AERONAUTICAL CHARTING MEETING
Instrument Procedures Group
Meeting 22-01 – April 25-26, 2022

RECOMMENDATION DOCUMENT

FAA Control # 22-01-368

Subject: MSA Center for Non-RNAV Procedures

Figure 1: KIXD ILS or LOC RWY 36

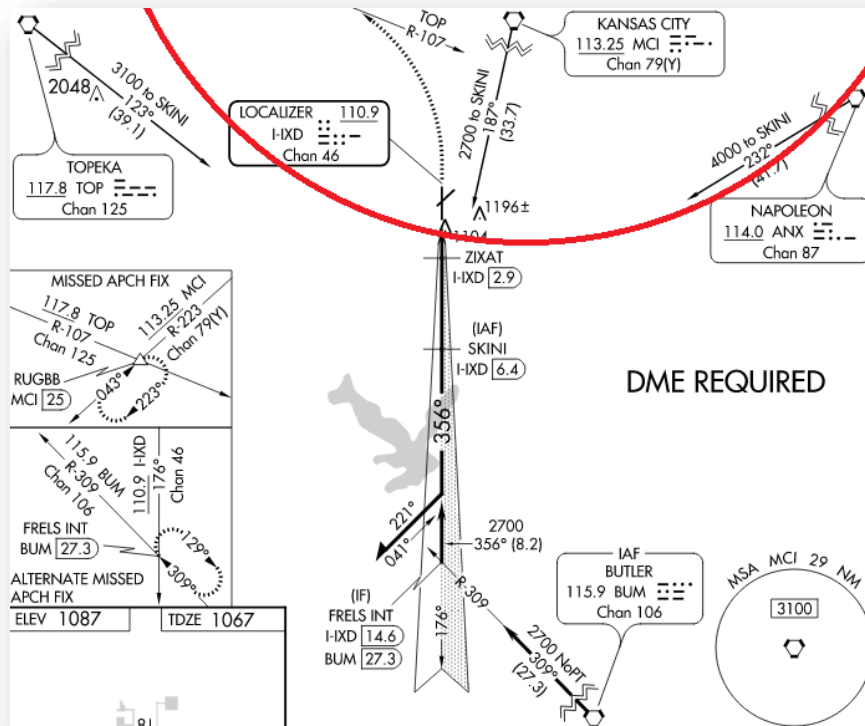
The KIXD ILS or LOC RWY 36 approach's MSA is centered on the MCI VORTAC which is 28.2 NM to the northeast of the KIXD airport. What this means is that the 29 NM radius of the MSA, shown in the image as a red circle, only protects arrivals from the northeast. The MSA does not protect any parts of the final approach or arrivals from the south, east or west.

Garmin would like to see the procedure design requirements for choosing an MSA center for non-RNAV procedures be amended to pick a location that is close to the airport reference point (ARP). Ideally, the majority of the non-RNAV procedures would use the ARP unless there is VOR/NDB very near the airport.

Figure 7: KCBE LOC/DME RWY 23

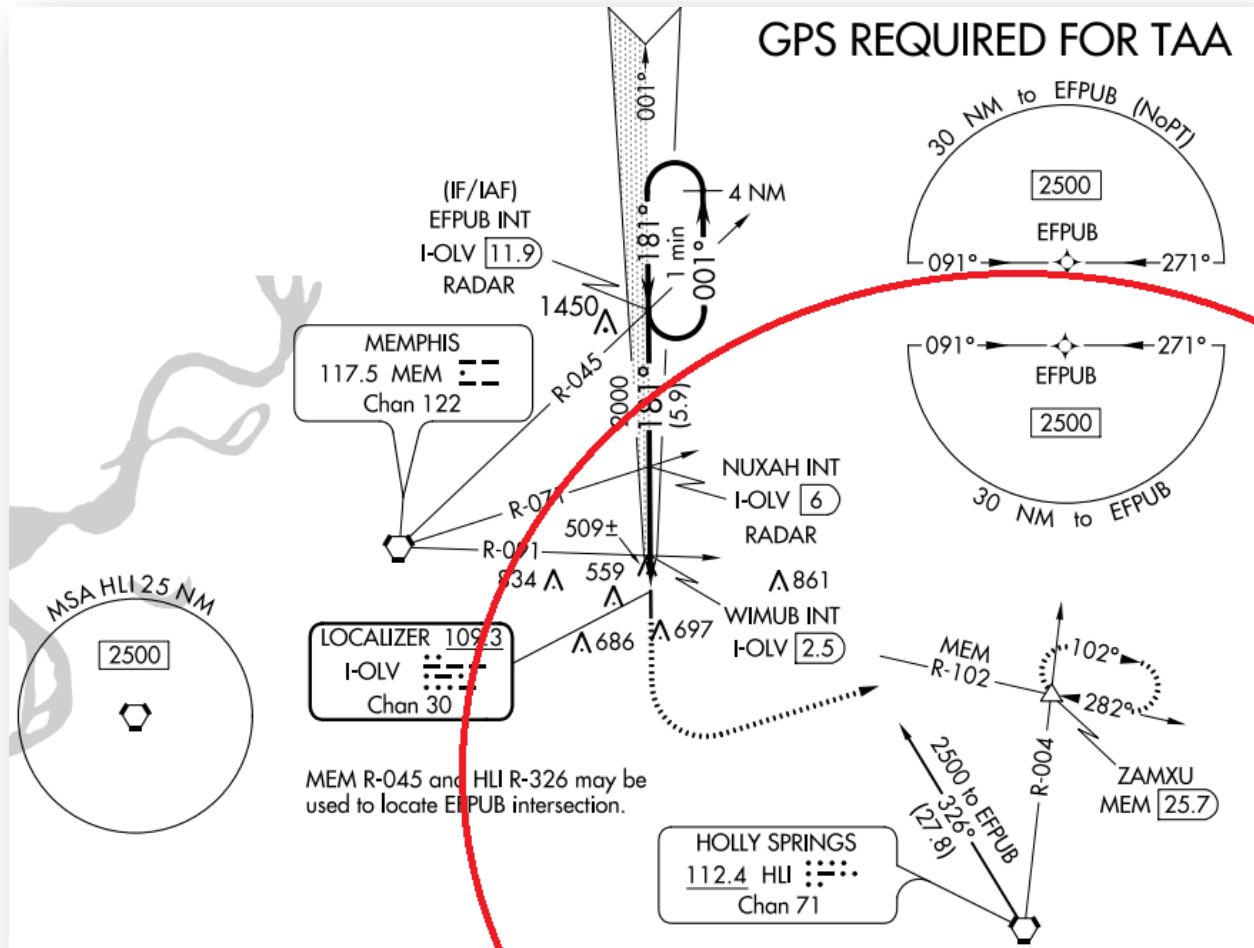
The KOLV ILS or LOC RWY 18 has a MSA and a TAA! The approach's MSA is centered on the HLI VORTAC which is 19 NM to the southeast of the KOLV airport and the TAA is centered on the EFPUB INT. The 25 NM radius of the MSA, shown in the image as a red circle, protects the arrivals from the southeast. The TAA would be needed for the rest of the arrivals but according to the plan-view note would require GPS equipment: "GPS REQUIRED FOR TAA".
